WAA
From: Thomas Wengert
To: McKnight, James
Date: Mon, May 21, 2007 2:20 PM
Subject: Fwd: FirstEnergy Nuclear Operating Company (FENOC) Exponent Failure Analysis Associates' Technical R

**Effect of Exponent Analysis of
Davis-Besse Reactor Vessel Head Wastage Event
On Industry Inspection Programs**

NEI commissioned an expert panel to review the First Energy Nuclear Operation Company (FENOC) report of December 15, 2006, authored by Exponent, entitled "Review and Analysis of the Davis-Besse March 2002 Reactor Pressure Vessel Head Wastage Event" to determine the potential impact on industry inspection programs for reactor vessel top head nozzles. The two main questions addressed by the panel and conclusions are as follows:

Figure 2-1
Davis-Besse Crack Growth Rates Relative to MRP-55 Data

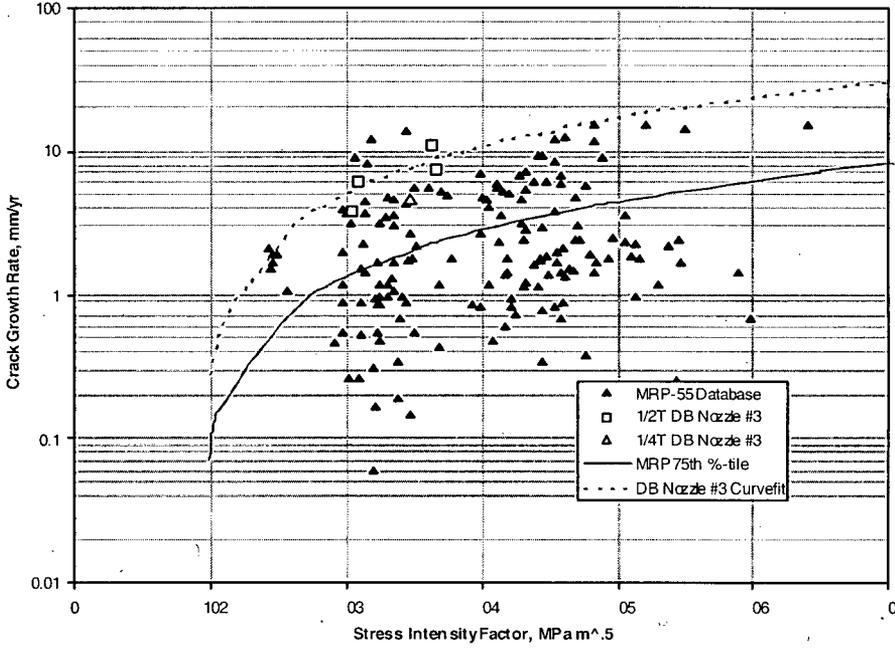
Exponent states that the crack growth rates of the Davis-Besse CRDM nozzle material were up to four times the growth rate of the MRP recommended 75th percentile crack growth curve reported in MRP-55. While this statement is correct, Figure 2-1 from MRP-55 shows that some of the material specimens in the MRP-55 database had crack growth rates even higher than the Davis-Besse material. Therefore, the Davis-Besse material is considered to be within the bounds of previously evaluated materials.

Figure 2-2
Projected Crack Growth and Industry Examination Requirements for a High Temperature Head under Crack Growth Rate Conditions Postulated in Exponent Report

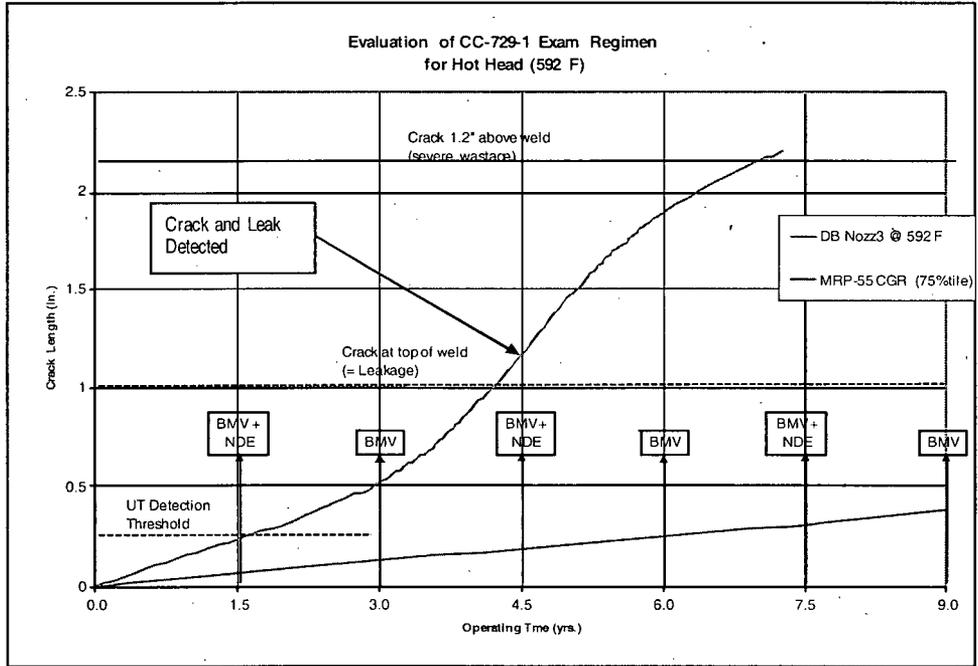
Deterministic predictions of crack growth for the three sample cases, using the crack growth rate curve for Davis-Besse Nozzle 3 referenced in the Exponent report are presented in Figures 2-2, 2-3 and 2-4. In each case, the crack growth rate equation was adjusted to the appropriate head operating temperature in accordance with the Arrhenius equation for crack growth (MRP-55¹). The figures also show the predicted crack growth in accordance with the MRP-55 75th percentile crack growth law for comparison purposes. Several significant crack sizes are shown as horizontal dashed lines on the figures, corresponding to the crack length at which detection by UT would be expected with high confidence (conservatively assumed = 0.25"), the crack length corresponding to the crack at the top of the weld, at which leakage is predicted, and a crack length of 1.2" above the weld, corresponding to the crack length that was discovered at Davis-Besse in 2002. Finally, vertical arrows are plotted on the figures corresponding to the NDE and BMV inspections that would be required at various refueling outages, per Table 2-1 above. Since inspections required per the NRC Order are somewhat more conservative than those required by Code Case N-729-1, only those required per the Code Case are shown on the figures. This produces the most conservative evaluation of the potential effect of the Exponent crack growth rate, since it corresponds to the least amount of inspection that would possibly be performed in the future. Also for conservatism, the initial baseline inspection was assumed to occur at a time when the postulated crack is just below the UT inspection threshold, and would thus be missed.

Figures 2-2 through 2-4 show that for each hypothetical case an NDE + BMV would be performed shortly after the postulated cracks are projected to reach the top of the welds, such that they would be well above the detection threshold of the ultrasonic NDE, and evidence of leakage would likely be detected by the BMV as well. These exams would be performed, and the cracking detected, well before the crack length approached the size predicted to have caused the severe wastage observed in the Davis-Besse head. These results, plus the conservative bounding nature of the deterministic evaluation, were a major factor in the panel's conclusion regarding adequacy of the current industry RPV top head examination program.
